April 9, 2003
LIC-03-0053

SUBJECT: Response to Request For Additional Information (RAI), Related to Exemption Request from the Requirements of 10 CFR 50, Appendix R, Section III.G.2 for Room 19 at Fort Calhoun Station (FCS)

**Response to NRC Request for Additional Information
For OPPD
Exemption Request from the Requirements of 10 CFR 50, Appendix R,
Section III.G.2 for Room 19 at FCS**

ATTACHMENT 2
PAGE 1
FORT CALHOUN STATION
FIRE AREA 32

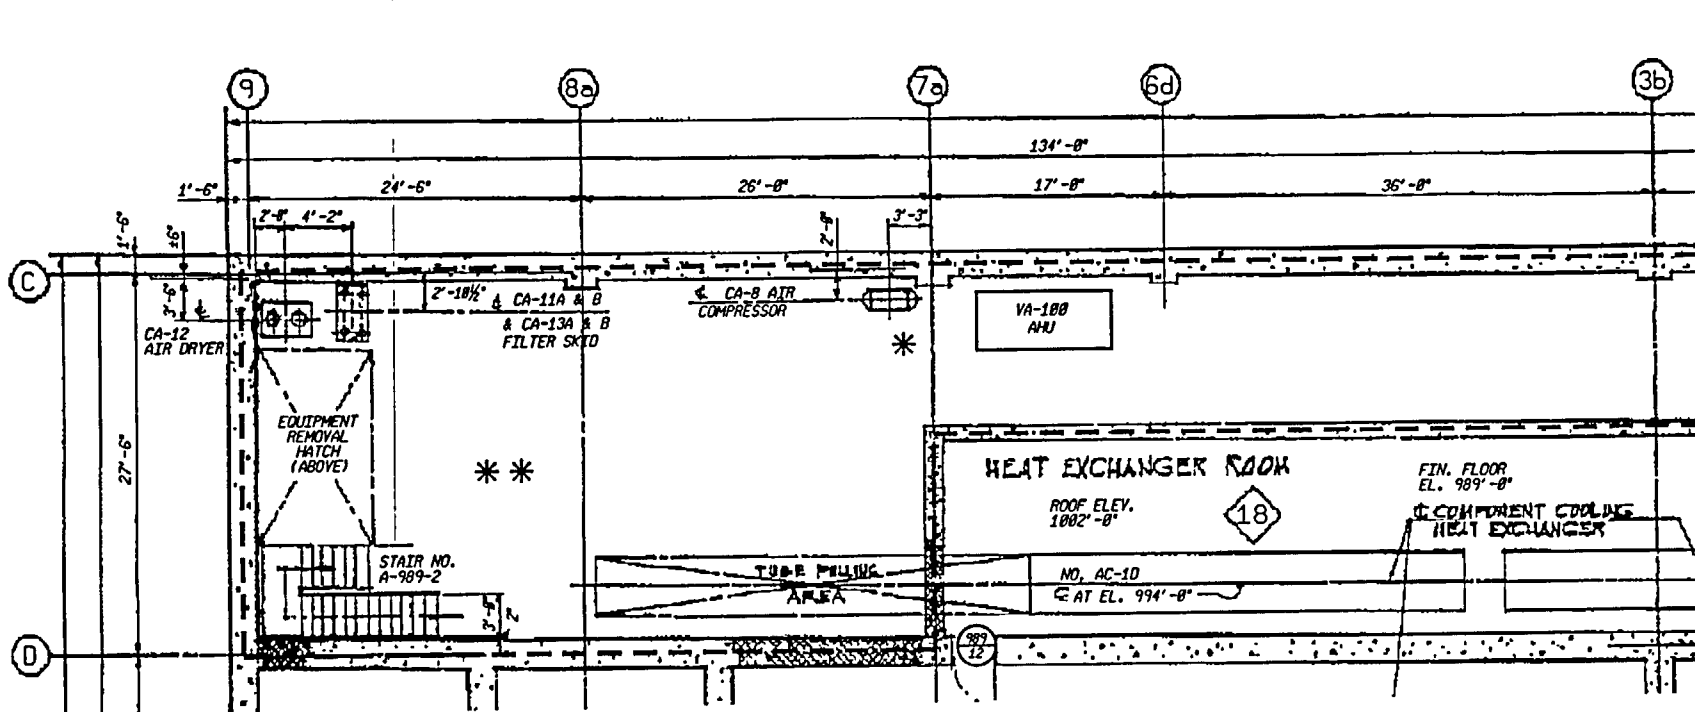
The 3-dimensional Figure 1 attached in the November 8, 2002, exemption request (exemption request) does not provide the appropriate level of detail for staff review. Please submit a revised drawing (P&ID) which shows the following for Fire Area (FA) 32:

- room dimensions (including height),
- location of compressors and auxiliary feedwater pumps,
- fire doors and fire barriers,
- the location of cable trays identified in exemption request (identifying both power and control cables),
- ventilation system details, and
- locations of any fixed and/or transient ignition sources.

Refer to Attachment 2 for additional clarification on room dimensions, major equipment locations, fire door and barrier designations, and the location of fixed and potential transient ignition sources. Ventilation for FA 32 is provided by supply and exhaust fans located in a different fire area. Approximately 2,200 cubic feet/minute (cfm) of non-cooled air is provided to the room with ductwork running along the west (supply) from columns 1a to 4a and east (exhaust) from columns 1a to 6d of the area. Approximately 3,400 cfm of cooled air is also provided for the room by air handling unit, VA-100, which is shown in Attachment 2. OPPD requests the NRC refer to the 3-dimensional Figure 1 submitted on November 8, 2002 for location of cable trays identified in the exemption request. This level of detail for the cable trays is difficult to display on plan view drawings and is much better depicted in the 3-dimensional color-coded figure previously submitted. Additionally, OPPD recommends that the NRC refer to the June 27, 2002 Public Meeting Presentation materials (which OPPD provided to the NRC) that depict detailed information within each zone. The Public Meeting Presentation materials contain color-coded cable trays with redundant tray designations, which may be helpful to the reviewers. Finally, OPPD recommends that the reviewers conduct a site visit to inspect FA 32. A site visit will help the reviewers better understand the layout and physical attributes of the fire area.
